TO: All Interested Bidders
SUBJECT: Invitation for Bids #16-1034CD
Wares Creek Pedestrian Bridge Replacement

ADDENDUM #1

- STEP 3**
SCALE: NTS

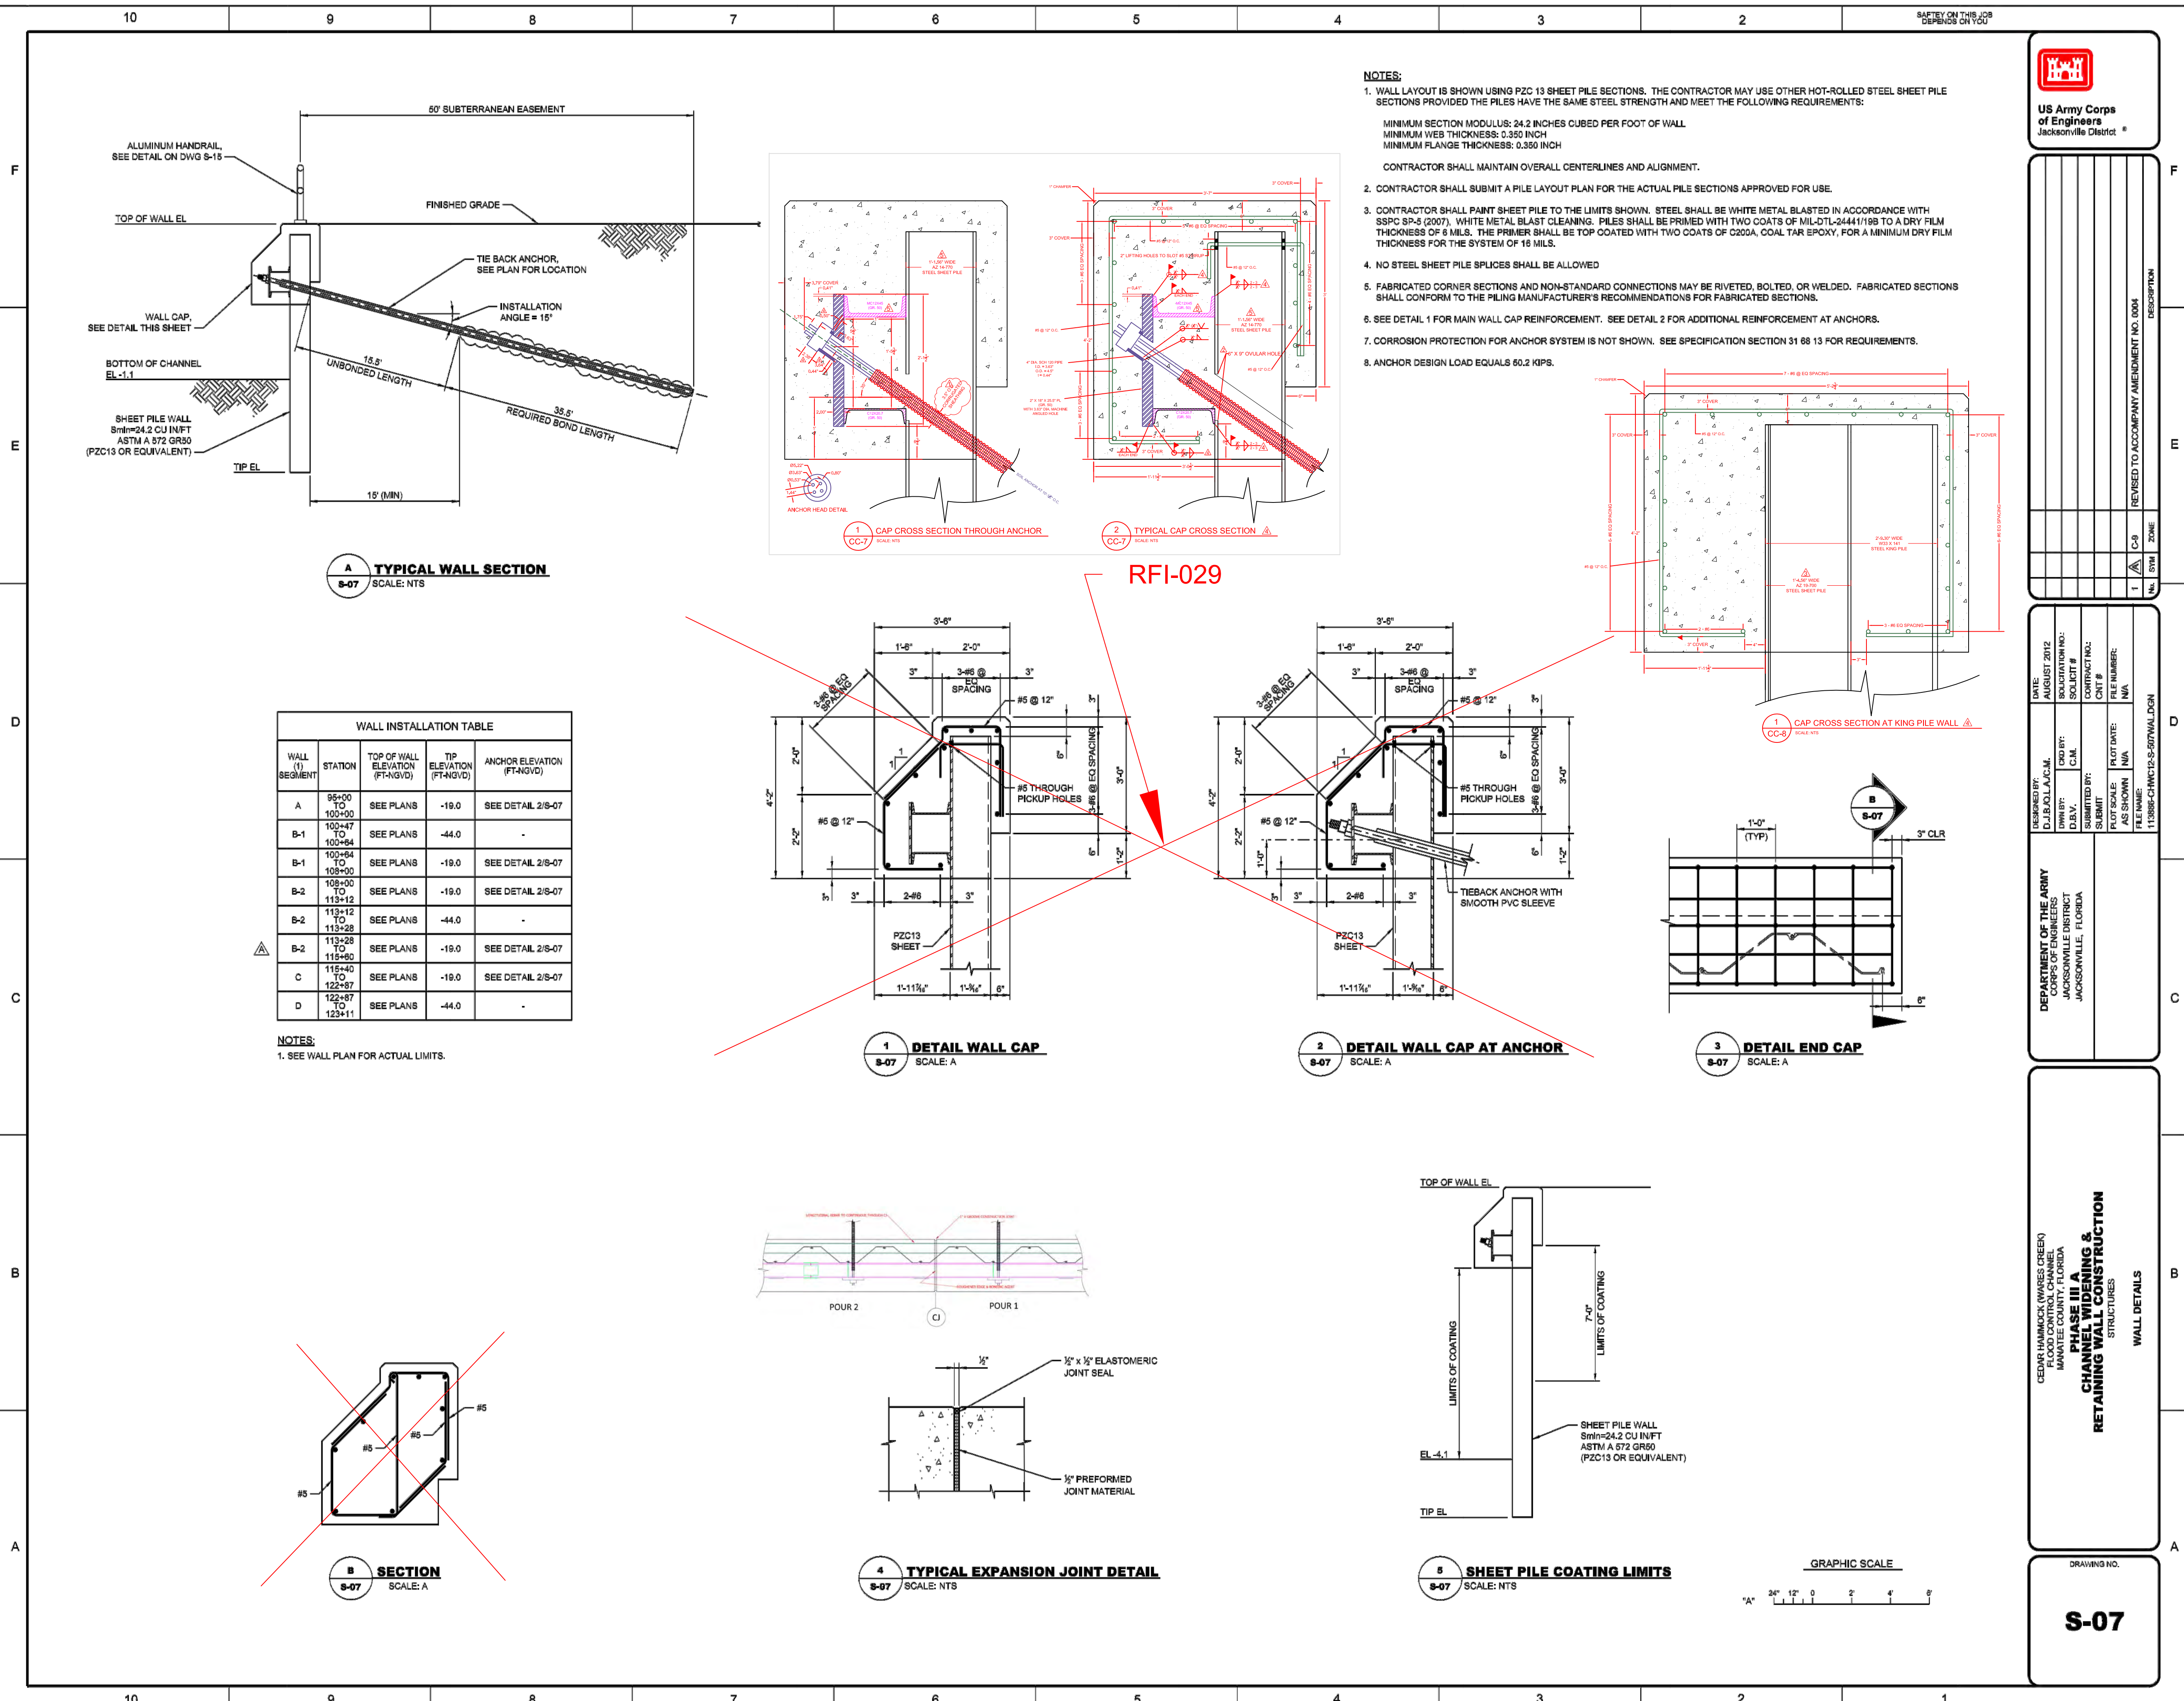
Question 9: Is there any as-built drawings for tie-backs?

Response 9: Please see attached as-built drawings for tie-back locations provided by USACE.
